Application Type: **Site Plan – Non-Residential**
 Status: **First Referral**
 Application Name: Parker and Pine F1 L4 - Car Wash
 Case/AP#: **SP20-118**
 Referral Received: October 18, 2021
 Comments Due: November 3, 2021

Application Location: Generally located on the southwest corner of Parker Road and Pine Lane

TOWN OF PARKER - FIRE/LIFE SAFETY:	C REVIEWED FOR CODE COMPLIANCE w/COMMENTS
---	--

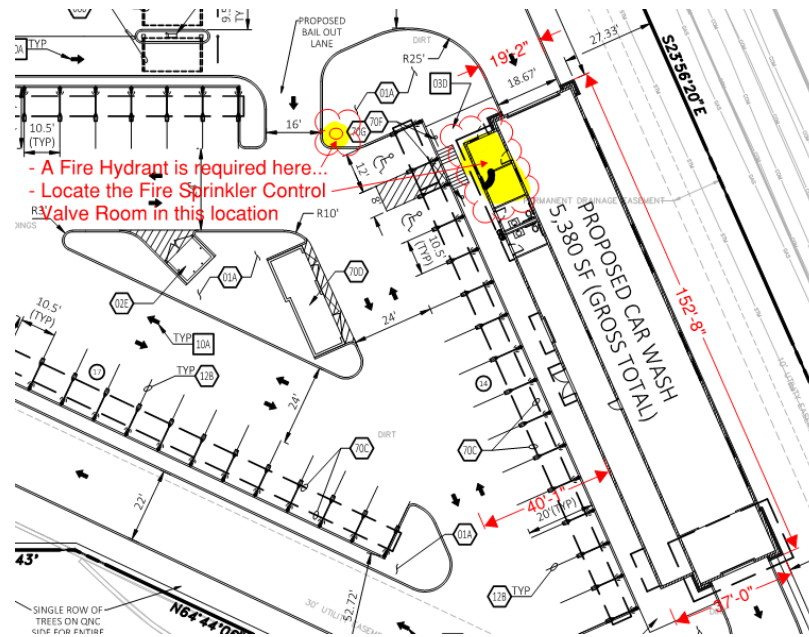
6. Based upon the size of the building (actual building 153'-0" x 37'-0"), it is not possible for the applicant to provide the required access to all portions of the building, as noted in [18 IFC 503.1.1 Buildings and Facilities]. This section states that "the fire apparatus access road shall comply with the requirements of this section and shall extend to within 150 feet of all portions of the facility and all portions of the exterior walls of the first story as measured by an approved route around the exterior of the building or facility". Based upon the size of the building, 153' + 37' = 190 feet (plus another 40 feet to center of the access that is perpendicular to the building), the access

to all portions of the building would be approximately 230 feet... the requirement cannot be met. *Partially satisfied; applicant has not noted, acknowledged, or addressed with current submittal specific to this response though the plan set does appear to have addressed the fact that the building is required to be sprinklered. The applicant will address all requirements noted in this letter and response both in writing as well as in the documentation when resubmitting. Note – The riser room shall be located closer to the n/w corner of the building... in closer relationship to the required fire hydrant.*

The code does allow the fire code official to extend this access on the basis that the building is fully sprinklered per NFPA 13, as required by [18 IFC 903.1.1]. A sprinkler suppression system, installed in accordance with NFPA 13, is required for this building. *Not satisfied; applicant has noted/acknowledged/addressed with the third submittal though the applicant has stated that this issue is to be “addressed by others”. Clarification as to this response is required. Note - The location of the riser room is acceptable. Satisfied; The riser room location will be accepted for this project.*
